Service Bulletin No: 24-006
Modification No: Inspection**Ref No: 148**
ATA Chapter: 24**ELECTRICAL POWER - GENERAL**
INSPECTION OF THE WIRING LOOM FOR CHAFING NEAR THE REAR GPS MOUNTING RACK**1. Planning Information****A. Effectivity**

Wiring Loom/Rear GPS-500 Mounting-Rack Backplate - Inspection
Figure 1

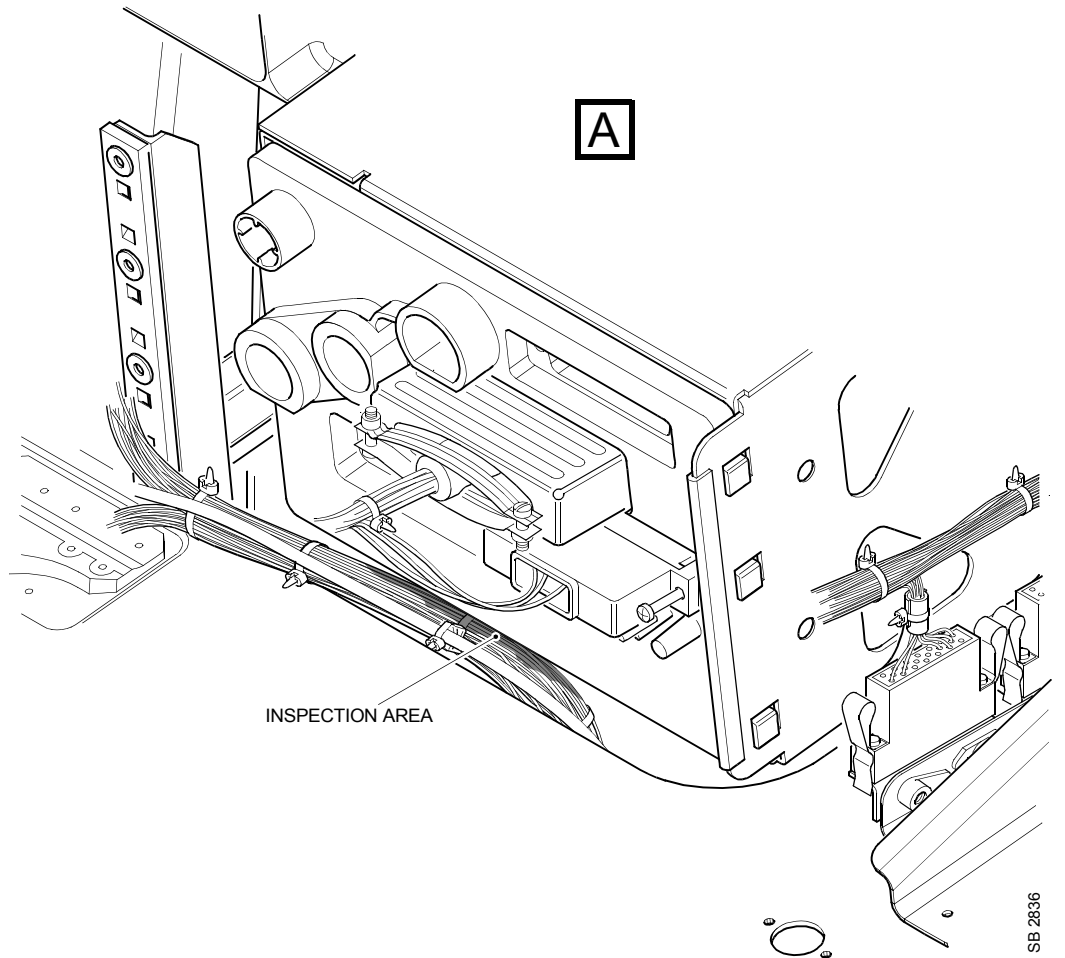
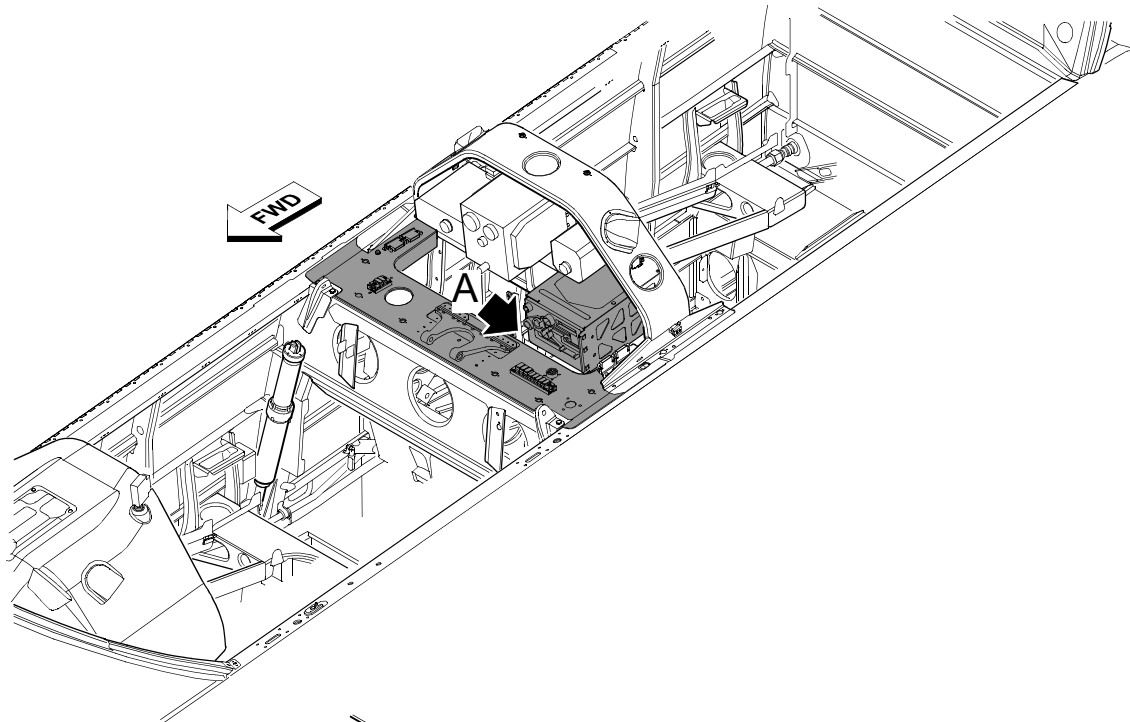
- (1) Do a visual inspection of the wiring loom adjacent to the backplate of the rear GPS-500 mounting rack (Ref. Fig. 1 and 24-00-00, Page Block 201, Para. 3.A.).

- (2) If you find signs of chafing and you can see the bare wires under the insulation, do these steps:
 - (a) Repair or replace the wire(s). If necessary, contact Pilatus for more information.

- (b) In the area where the wiring loom is adjacent to the backplate, remove the cable ties that hold the wiring loom.
 - (c) Move the wiring loom, as much as possible, away from the backplate to get clearance between the wiring loom and the backplate.

- (d) Install the protection sleeve (P/N 917.96.92.155) (Ref. 24-00-00, Page Block 201, Para. 3.B.).
 - (e) Install the cable ties (Material No. P09-005 and/or P09-008 and/or P09-014), as necessary, to hold the wiring loom.

- (3) If you find signs of chafing but you cannot see bare wires under the insulation, do these steps:
 - (a) In the area where the wiring loom is adjacent to the backplate, remove the cable ties that hold the wiring loom.

- (b) Move the wiring loom, as much as possible, away from the backplate to get clearance between the wiring loom and the backplate.
 - (c) Install the protection sleeve (P/N 917.96.92.155) (Ref. 24-00-00, Page Block 201, Para. 3.B.).

- (d) Install the cable ties (Material No. P09-005 and/or P09-008 and/or P09-014), as necessary, to hold the wiring loom.
- (4) Report your findings to Pilatus.
